December 14, 1977 L-77-380

Re: Florida Power & Light Company Docket Nos. 50-250, 50-251, and 50-335 Request for Information

FLORIDA POWER & LIGHT COMPANY DOCKET NOS. 50-250, 50-251, & 50-335 NRC REQUEST FOR INFORMATION SYSTEM DISTURBANCE (5/16/77)

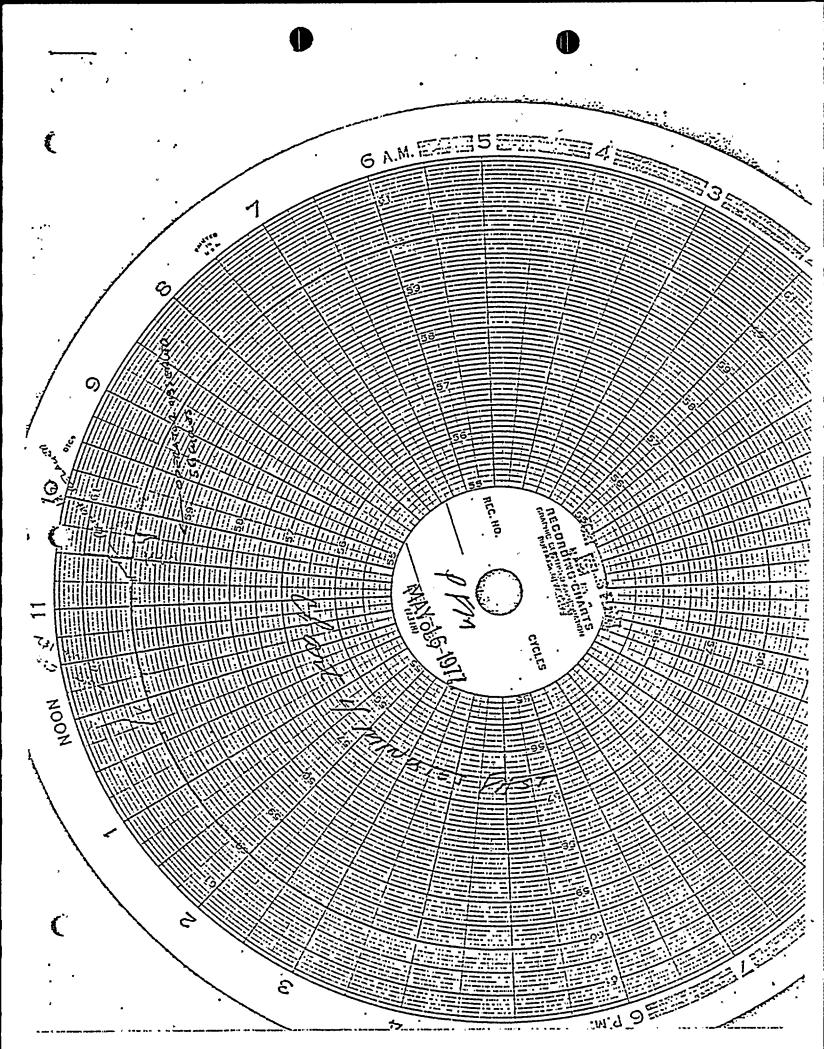
So that we may better understand the causal relationships between the events that occurred on May 16, 1977, please provide the following information:

- 1.1 A time trace of the real power loading on the Ft. Myers-Ranch 240kV line for the time period 10:08-10:24 am;
- 1.2 The normal rating of this line (MW, MVA);
- 1.3 The long time and short time emergency ratings;
- 1.4 If the ratings are given in MW, indicate the power factor to which they apply;
- 1.5 The MVA load (or the power factor) on the line when it relayed open;
- 1.6 If the information in Items 1.4 and 1.5 is not available, provide power factor or equivalent information at points as close to this line as available; and
- 1.7 The line loading information (power, power factor, etc.) on this line for each occasion in the past when it relayed open.

1.6 The combined MW load on the Ft. Myers-Ranch 138kV and 240kV circuits can be determined with reasonable accuracy by adding the "instantaneous" change in tie line flow on the TEC ties, the change in generation on the west coast plants, FM1, FM2 and MT1, and the change in load. The change in transmission losses is included with the load. From these changes, the flow west to east on the Ranch-Ft. Myers circuits is found to be 595 MW. From past history of the division of load, the MW load on the 240kV line is estimated at 420 MW.

The oscillatory nature of the alarms tend to indicate that the loading was near the alarm set points. It can be concluded from the above that, at the time of tripping, the line load was in excess of 418 MW and less than 147 MVAR.

The Fort Myers-Ranch line tripped at both ends with a ground pilot target at Ranch and a Zone 1 and ground instantaneous targets at Fort Myers. Broward, Midway and Ringling oscillographs recorded a phase-to-ground fault at this time. The Ringling oscillogram indicated a "B" phase-to-ground fault.

The attached oscillogram from Ringling shows a discrete step

change in current, indicating a fault rather than an overcurrent. The oscillograph is a 32 channel machine, but due to play back limitations, the output is printed on three separate pages.

Charts of frequency at Ft. Myers (to show high frequency following the tripping and explain the load rejection of the plants). Oscillogram from Ringling which shows that the system was not swinging wildly but relatively stable following the fault.
